Agenda – Appeal Committee – September 13, 2022**PUBLIC HEARINGS**

**Item No. 2 Appeal – Variance – 821-827 Grosvenor Avenue
 (Fort Rouge-East Fort Garry Ward)
 File DAV 226612A/2021C [c/r DCU 226609A/2021C]**

Appeals were received against the decision of the Director of Planning, Property and Development to approve a Variance on “the land” as follows:

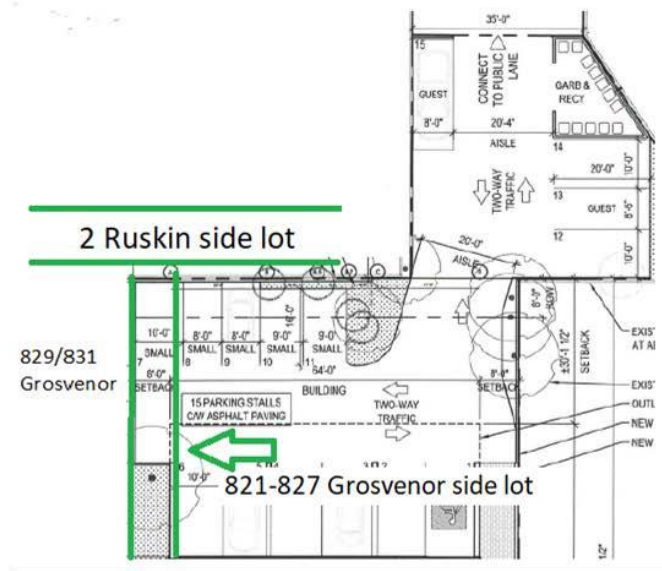
- As well, in order to obtain the 15 spaces, the developer has planned to use space that directly abuts both the properties of 829/831 Grosvenor (37 feet) and 2 Ruskin Row (57 feet) without any setback between the parking pad and these adjacent private property lines. Please note that there is no public access lane between the proposed new development and these 2 properties at this corner of the proposed parking lot location.

- Within the Corydon-Osborne Area Plan document, section 11. (3) (f): "for multiple-family dwellings, the required interior side yard is a minimum of 4 feet and increases 2 feet per story above the second story."

- Parking Spot 7 (see figure below) does not comply with section 11. (3) (f).
- The adjacent property at 2 Ruskin that abuts the new development has a frontage westerly to Ruskin Row. Therefore, 2 Ruskin's side lot runs east/west from Ruskin, while the side lots for 821-827 run north/south. The minimum side lot requirement referenced in 11. (3) (f) should apply similarly in reference to 2 Ruskin because 2 Ruskin's side lot abuts the northern section of the new development's parking lot, namely parking spots 7, 8, 9, 10, and 11. Therefore the parking spots should be designed to be at minimum 4 feet away from the southern edge of 2 Ruskin's property line.

Back Lane Access

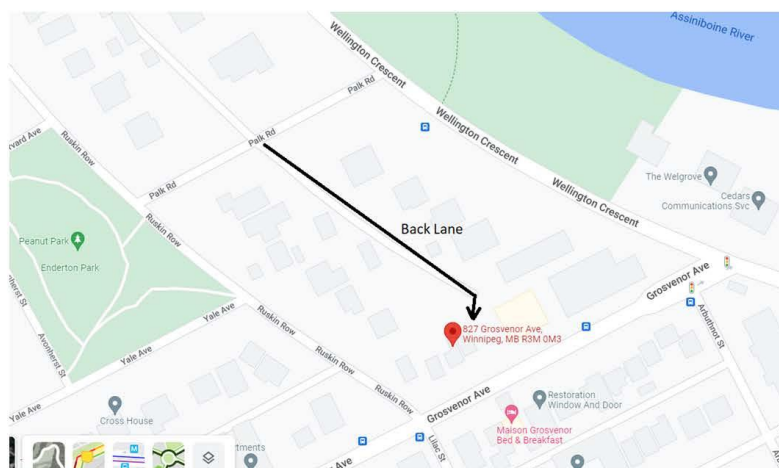
- Public Works proposed and approved a one-way access to and from the development through a dead-end one-way only back alley that is approximately 520 feet long.
- How will snow removal through a 520 foot dead-end alley be completed? In previous years large amounts of snow were dumped into the empty lot that will now become the development.
- Currently, garbage removal is done whereby the truck must back up the full length of the alley as there is insufficient space to turn around at the end of the lane.
- Although the back lane has been upgraded it is not wide enough for two lane traffic and any vehicles that try to go by each other will need to encroach on to private property to do so.

Preservation of Mature Trees

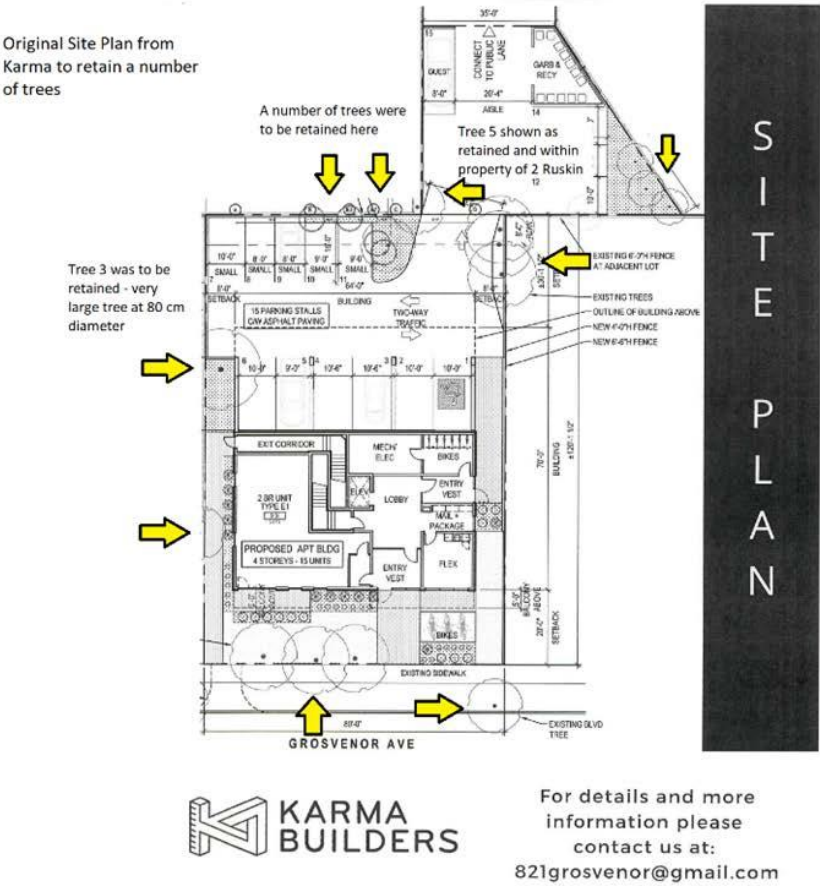
- The arborist report presented by the developer recommends removing 32 of the 36 trees on this lot (of which 34 are private and 2 are on public lands) and preserving at total of only four (4) trees (Trees 2, 17, 35, 36).
- Almost all the trees are on the periphery of the property and would be minimally impacted by the ground disturbance of the proposed development. The trees on the north side of the lot (Trees 4, 5, 8, 9, 30, 31, 32, 33, 34) are over 30 feet away from the foundation of the building and were indicated on the original site plan to be preserved. Trees along the north east side of the triangular lot parking area also meet this criterion.
- The original site plan from Karma Builders had a large number of trees proposed to be preserved – why was this plan changed so significantly (see figure below).

- The Winnipeg Public Works Department, within their tree removal guidelines states that “where trees in fair to good condition are proposed to be removed...” that for any trees that are “30cm+ The Urban Forestry Branch’s position is to deny removal”

- Tree 3 is one of the largest standing trees in the neighborhood at 80 cm diameter and was also indicated on the original site plan to be preserved.
- In communication with Dwell Design in late April 2022, it was verbally confirmed by Braydin Huyne to me that they had intended to save trees 4, 30, and 31 as per their initial design.

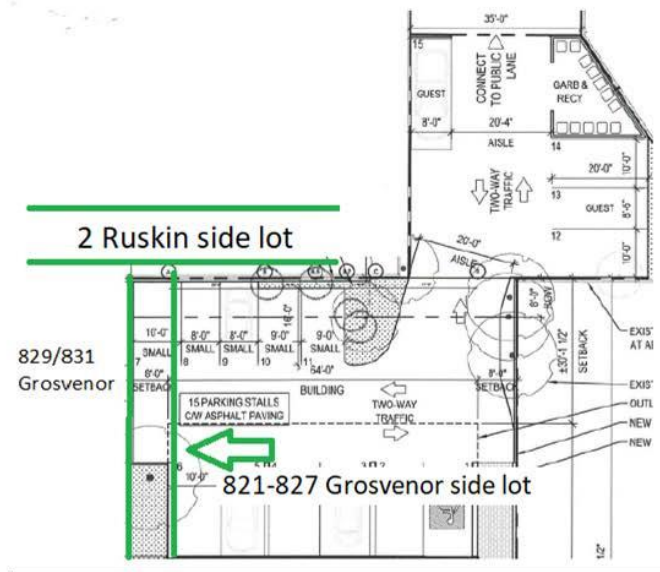
- Parking spots 8, 9, 10, and 11 all sum up to 26.5 feet are undersized according to the Winnipeg By-Law (Parking Spot 7 sums up to 27.5 feet and is also undersized).

- As well, in order to obtain the 15 spaces, the developer has planned to use space that directly abuts both the properties of 829/831 Grosvenor (37 feet) and 2 Ruskin Row (57 feet) without any setback between the parking pad and these adjacent private property lines. Please note that there is no public access lane between the proposed new development and these 2 properties at this corner of the proposed parking lot location.

- Within the Corydon-Osborne Area Plan document, section 11. (3) (f): "for multiple-family dwellings, the required interior side yard is a minimum of 4 feet and increases 2 feet per story above the second story."

- Parking Spot 7 (see figure below) does not comply with section 11. (3) (f).
- The adjacent property at 2 Ruskin that abuts the new development has a frontage westerly to Ruskin Row. Therefore, 2 Ruskin's side lot runs east/west from Ruskin, while the side lots for 821-827 run north/south. The minimum side lot requirement referenced in 11. (3) (f) should apply similarly in reference to 2 Ruskin because 2 Ruskin's side lot abuts the northern section of the new development's parking lot, namely parking spots 7, 8, 9, 10, and 11. Therefore the parking spots should be designed to be at minimum 4 feet away from the southern edge of 2 Ruskin's property line.

Back Lane Access

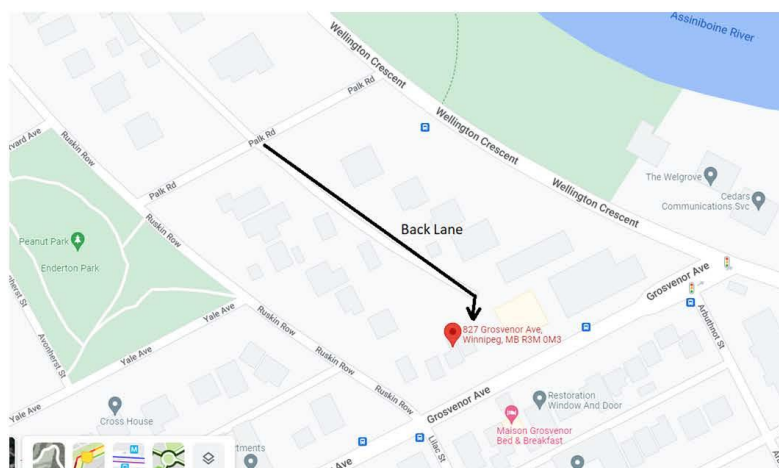
- Public Works proposed and approved a one-way access to and from the development through a dead-end one-way only back alley that is approximately 520 feet long.
- How will snow removal through a 520 foot dead-end alley be completed? In previous years large amounts of snow were dumped into the empty lot that will now become the development.
- Currently, garbage removal is done whereby the truck must back up the full length of the alley as there is insufficient space to turn around at the end of the lane.
- Although the back lane has been upgraded it is not wide enough for two lane traffic and any vehicles that try to go by each other will need to encroach on to private property to do so.

Original Site Plan from Karma to retain a number of trees

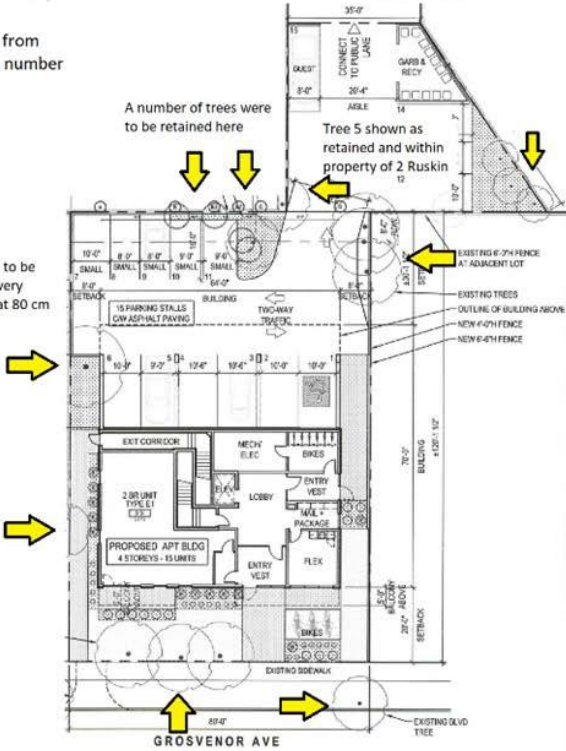
- The arborist report presented by the developer recommends removing 32 of the 36 trees on this lot (of which 34 are private and 2 are on public lands) and preserving at total of only four (4) trees (Trees 2, 17, 35, 36).
- Almost all the trees are on the periphery of the property and would be minimally impacted by the ground disturbance of the proposed development. The trees on the north side of the lot (Trees 4, 5, 8, 9, 30, 31, 32, 33, 34) are over 30 feet away from the foundation of the building and were indicated on the original site plan to be preserved. Trees along the north east side of the triangular lot parking area also meet this criterion.
- The original site plan from Karma Builders had a large number of trees proposed to be preserved – why was this plan changed so significantly (see figure below).

- Tree 3 is one of the largest standing trees in the neighborhood at 80 cm diameter and was also indicated on the original site plan to be preserved.
- In communication with Dwell Design in late April 2022, it was verbally confirmed by Braydin Huynen to me that they had intended to save trees 4, 30, and 31 as per their initial design.
